Subject: Report of Defect (10CFR21)

BULLETIN NO. LAS-6

- APPLICABLE TO: La Salle County Station
Commonwealth Edison Company
Thermal Hydrogen Recombiners
Serial Nos. 211A and 211B
- SUBJECT: Operation of Hydrogen Recombiner System With
Disconnect Switch Part Number 9422-RC-1 and Micro Toggle Switches
Part Number 12TS1-2 Bypassed.

WIRING DIAGRAM
HYDROGEN RECOMBINER
SKID
DNG NO.
N116000121

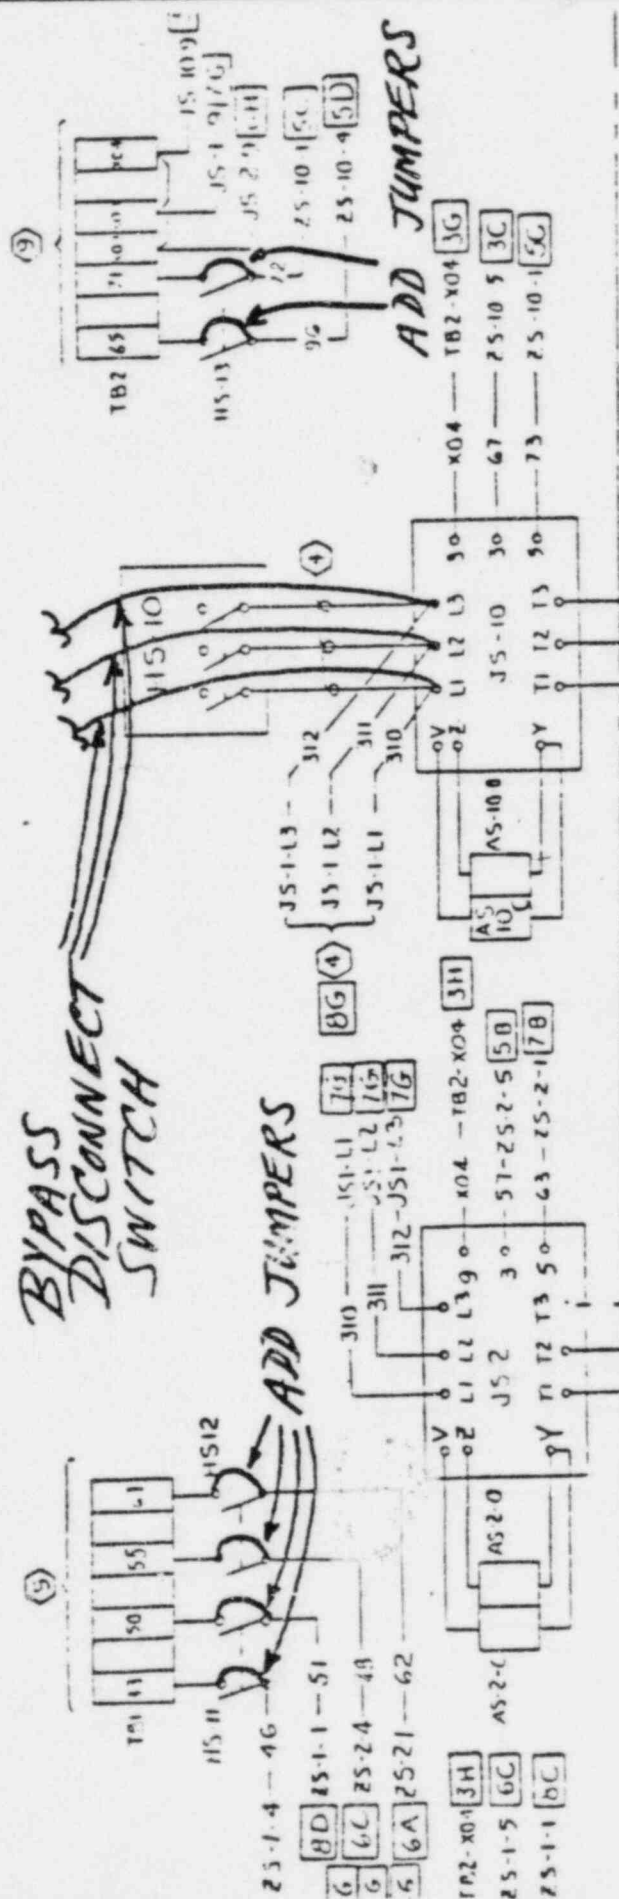
Step	Activity	Compliance	
		Yes	No
1.	Disconnect all power sources to the recombiner.		
2.	Remove wires numbered 310, 311, and 312 connecting L1, L2, and L3 to HS-10 (See drawing N116000121).

3.	Connect facility 12AWG power wires 480 Vac 3-phase 60 Hz directly to JS-10, terminals L1, L2, and L3 Phase A, B, and C, respectively.		
4.	Add warning decal to bypass switch cover as follows: CAUTION 480 VOLTS AC WARNING Disconnect switch bypassed; turn off facility power to recombiner before opening this cabinet.

5.	Install bypass jumpers to the following toggle switches in the valve operator starter cabinet (See drawing N116000121). a. At switch HS-11 add jumper connecting wire 43 to 46 and wire 50 to 51. b. At switch HS-12 add jumper connecting wire 48 to 55 and wire 61 to 62. c. At switch HS-13 add jumper connecting wire 65 to 96 and wire 71 to 72.
